**WARRANTY
BULLETIN**

Wb08-13

| SUBJECT : REPLACEMENT OF THE DASHBOARD STATIONNARY REGENERATION SWITCH - DETROIT DIESEL S60 ENGINE ONLY | |

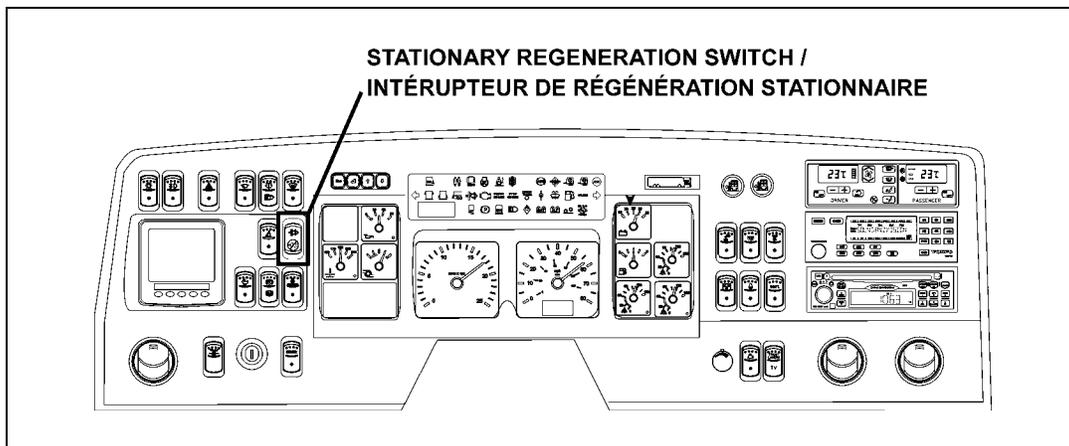
On all vehicles mentioned above (with Detroit Diesel S60 engine), it is necessary to replace the existing dashboard regeneration switch. Prevost has determined that this switch would not be able to initiate a stationary regeneration after a DDEC VI software upgrade.

It is imperative that your new switch be retrofitted BEFORE your vehicle is brought into the nearest Detroit Diesel distributor for a DDEC VI software upgrade. If the software upgrade is done first, then the regeneration switch will not function.

| Part No. | Description | Qty |
|----------|---------------------|-----|
| 564106 | Regeneration switch | 1 |

Before removing the existing switch, check the part number on the label affixed on the switch housing. If you read Prevost part number #564106, the switch in place is the new one and it does not need replacement.

2. Unplug the connector behind existing regeneration switch.
3. From behind the dashboard, press the tabs on the switch housing and remove the switch. The switch will come out on the front side of the dashboard.
4. Insert the new regeneration switch and plug the connector.
5. Reinstall the dashboard cover.
